AGENDA
Veneta Planning Commission
TUESDAY – December 1, 2015 – 6:30 p.m.
Veneta City Hall

**VENETA PLANNING COMMISSION'S
STAFF REPORT**

Veneta Veterinary Hospital – Site Plan Review (Track 2 Site Plan Review)

Veneta Veterinary Hospital – Site Plan Review (Major Amendment)

1 SITE PLAN
 C1.1

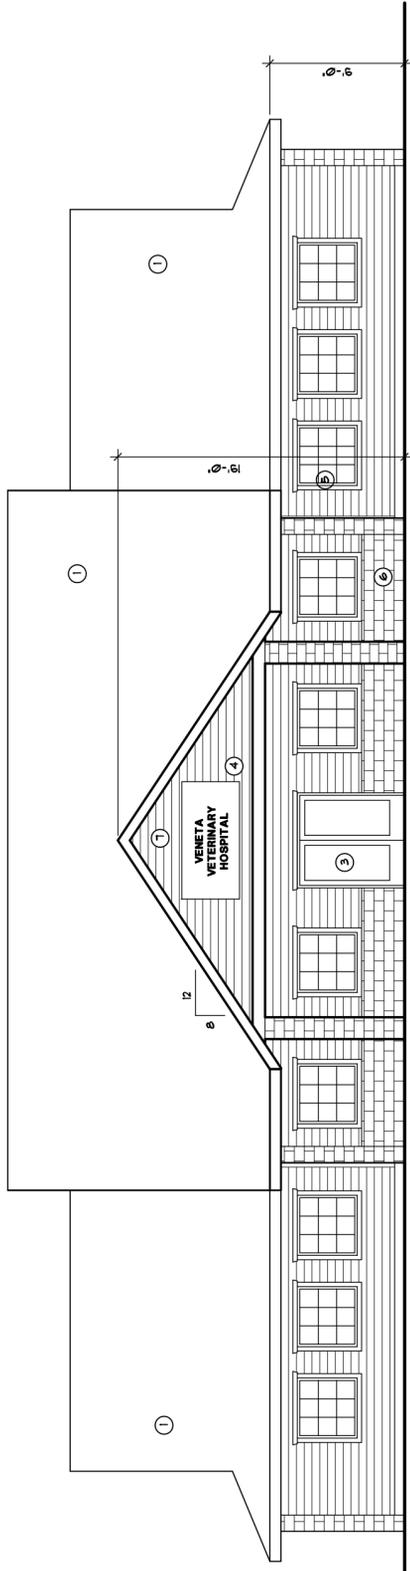
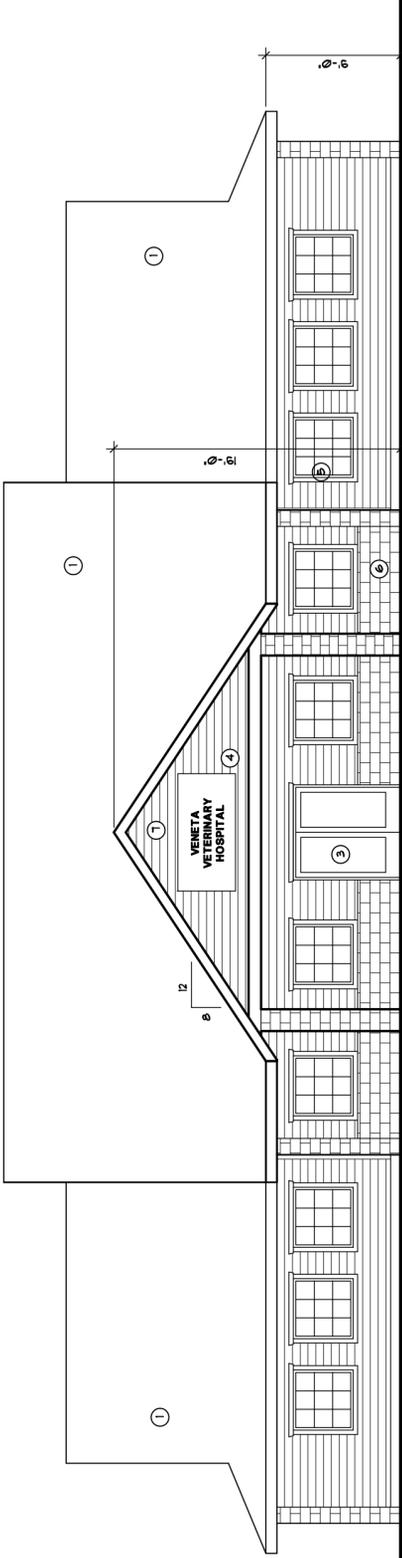
The applicant appreciates your consideration of 12 paved parking spaces out of a total of 36 parking spaces to be located in the front of the hospital and adjacent to Jeans Road (see sheet C1.1R dated revised 10-27-15)

Specifically, the Planning Commission is being asked to determine if the twelve (12) parking stalls with two-way drive aisle, in front of the building, as depicted on the revised site plan (dated 10-27-15) are considered a 'parking lot'.

The proposal is consistent with this standard. The applicant has submitted a site plan (dated 10-27-15) depicting twelve (12) parking stalls immediately in front of the building entrance. The twelve (12) parking stalls located to the front of the building entrance are not considered a parking ‘lot’ but instead parking stalls to provide reasonable accessibility to the front entrance of the building when taking into account the emergency needs of the proposed use. The revised site plan is consistent with the intent of VLDO Section 5.20(3)(c) – Location standards for parking lots. Condition #10.a. of the original approved Site Plan has been met.

As conditioned, the proposal is consistent with this standard. The applicant has submitted a revised site plan (dated 10-27-15) depicting twelve (12) parking stalls (a parking lot) immediately in front of the building entrance. The twelve (12) parking stalls located to the front of the building entrance are considered a parking ‘lot’ in terms of VLDO Section 5.20(3)(c) – Location standards for parking lots. Prior to construction, the applicant shall submit and receive approval of a revised Site Plan depicting all parking lots to be located to the side or rear of the building in accordance with VLDO Section 5.20(3)(c) – Location standards for parking lots.

1 SOUTH ELEVATION

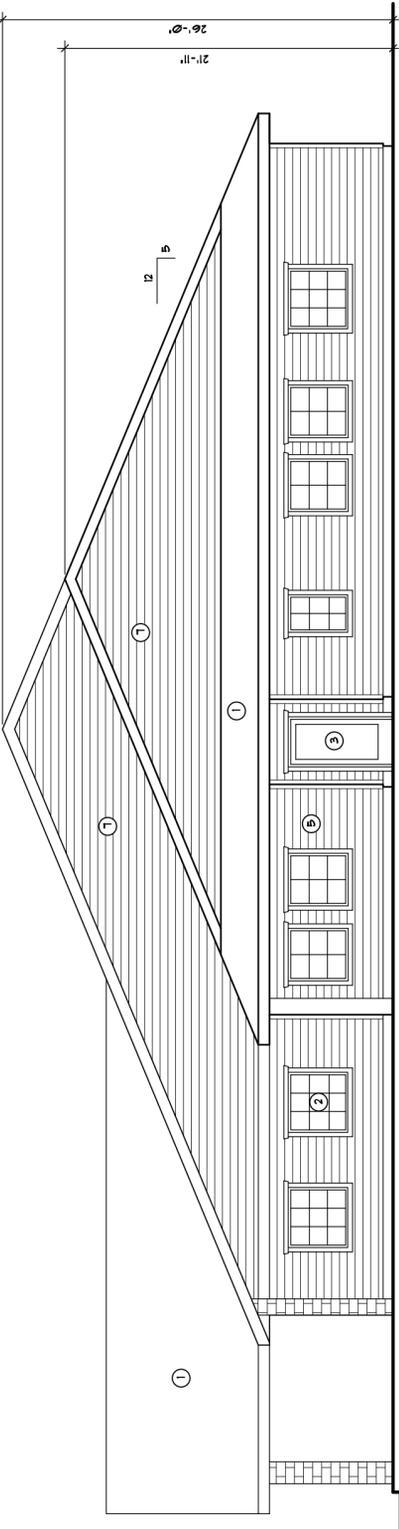
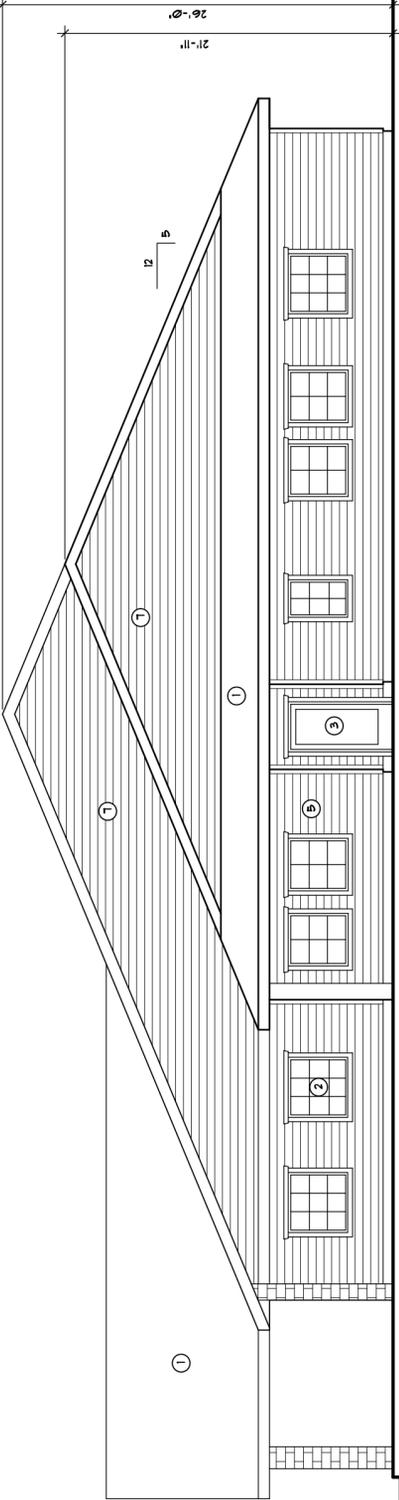
The submitted south elevation (dated 10-27-15) depicts a higher level of density detailing than what is required under the base code. Particularly, the varied materials/ textures within the façade including horizontal lap hardi-plank siding, CMU wainscot, CMU columns, CMU covered entry porch, CMU building corners and colored fenestration. As the applicant has stated, the proposed use, a veterinary hospital, requires a certain amount of privacy and security for exam rooms or areas that adjoin an exterior wall. The intent of the design standard being adjusted (VLDO 5.13(2)(i) and guideline being adjusted has been met as the south and east elevations provide visual interest from the outside of the building and natural surveillance from the inside, at a pedestrian level and large blank walls have been avoided in conformance with Guideline #6 of VLDO Section 5.13(3) – Design Guidelines.

The proposal is consistent with this standard. The applicant is proposing approximately twenty-seven percent (+/-27%) of the revised south elevation (dated 10-27-15) to contain “openings” (i.e. windows, doors) whereas the code requires sixty percent (60%) of the south facing elevation to contain “openings” per Veneta Land Development Ordinance No. 493 (VLDO), Section 5.13(2)(i) – Commercial and Mixed Use Design Standards. The applicant is proposing approximately twenty-six percent (26%) of the revised east elevation to contain ‘openings’ (i.e. windows, doors) whereas the code requires thirty-percent (30%) of the east elevation to contain ‘openings’ per VLDO, Section 5.13(2)(i) – Commercial and Mixed Use Design Standards. The purpose and intent of the design standard being adjusted (VLDO 5.13(2)(i) has been met as the south and east elevations will enhance the appearance, safety and economy of Veneta and provide visual interest from the outside of the building and natural surveillance from the inside, at a pedestrian level.

The proposal is consistent with this standard. The design guideline which is requested to be adjusted is Guideline #6 per VLDO Section 5.13(3) – Design Guidelines. The submitted south elevation (dated 10-27-15) depicts a higher level of design detailing than what is required under the base code. Particularly, the varied materials/ textures within the façade including horizontal lap hardi-plank siding, CMU wainscot, CMU columns, CMU covered entry porch, CMU building corners and colored fenestration including the following different colors; Forest green, Light green, natural stone and light brown. The design guideline (Guideline #6) for both the south and east elevation have been met as large blank walls have been avoided in conformance with Guideline #6 of VLDO Section 5.13(3) – Design Guidelines.

2 EAST ELEVATION

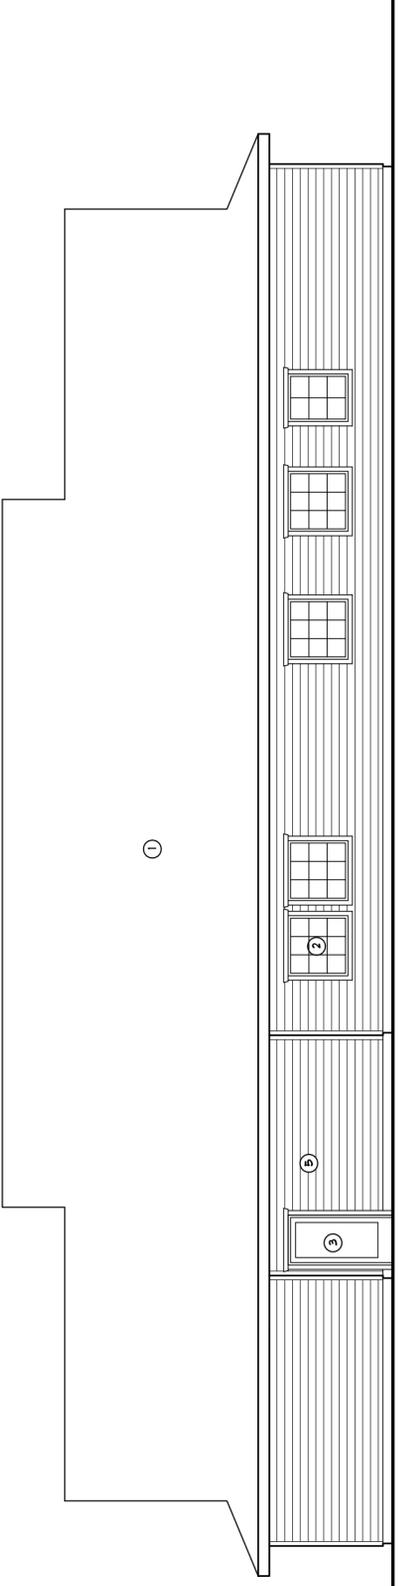
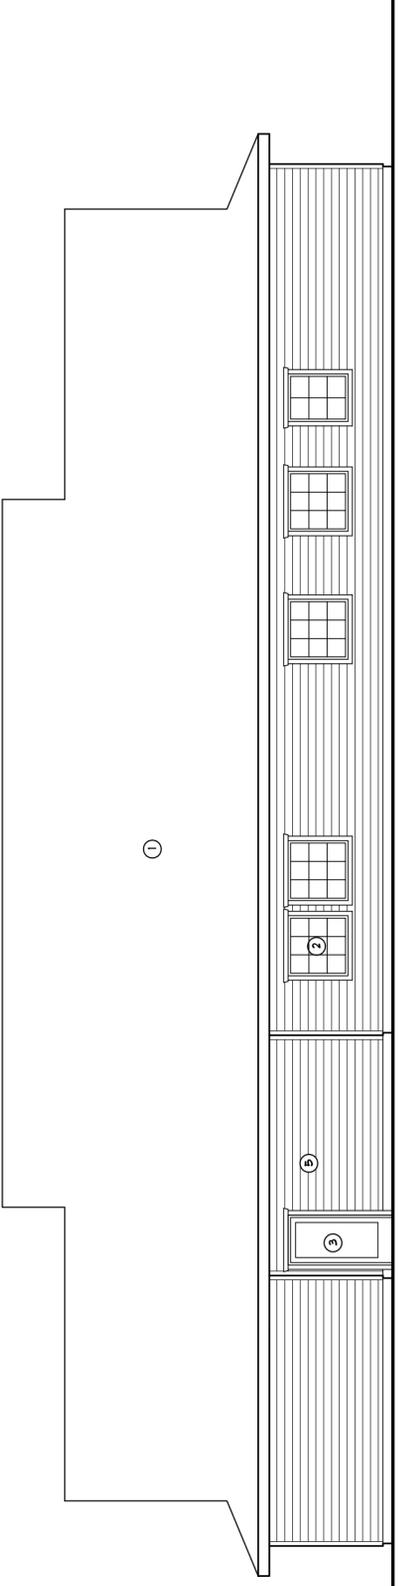
The applicant is proposing approximately twenty-six percent (26%) of the revised east elevation to contain ‘openings’ (i.e. windows, doors) whereas the code requires thirty-percent (30%) of the east elevation to contain ‘openings’ per VLDO, Section 5.13(2)(i) – Commercial and Mixed Use Design Standards. The standard is reduced by one-half for the east facing elevation for an elevation facing a secondary street when a building faces more than one street. The intent of this particular criteria is described in VLDO, Section 5.13(3), Guideline #6: Wall Openings such as windows, doors, balconies are required in order to “*prevent designs with large blank walls*” in areas of pedestrian traffic in order to welcome pedestrians, create a sense of place and promote visual surveillance of public spaces from inside the building for security. In general, the more pedestrian traffic that is expected in an area, the more important the design incorporate these ‘openings’.

Exhibit F

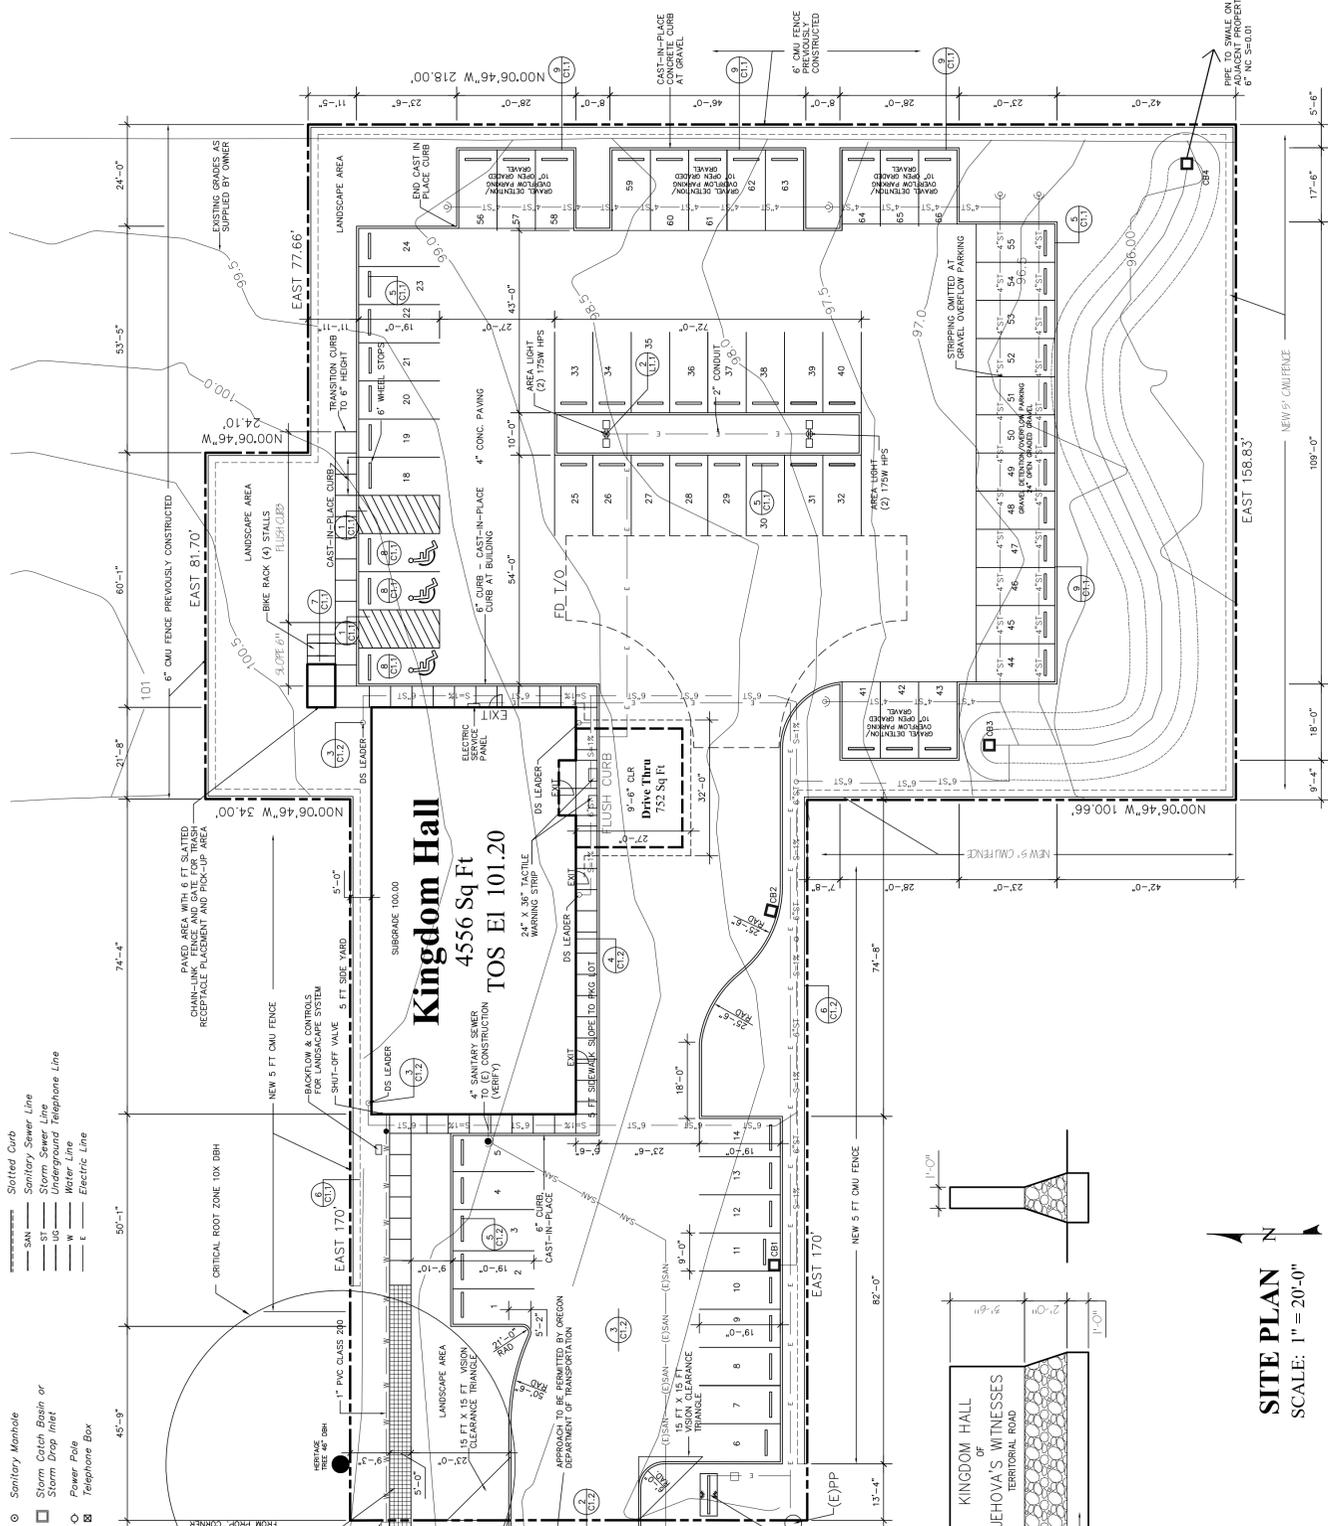
The applicant has inquired on past conformance with the off-street parking standards for the previous Site Plan approval of 'Kingdom Hall' (City File #SR-4-09) which is located at 88053 Territorial Road. Attached as Exhibit 'E' and 'F' is the Kingdom Hall approved Site Plan and related findings for reference. The applicant is assuming the intent of the code is to encourage pedestrian scale or relationship to the built environment, at one and the same time placing vehicles secondary to persons. The applicant asks the planning commission to review the needs of this application in regards to parking between the street and the building in a similar manner as Kingdom Hall.
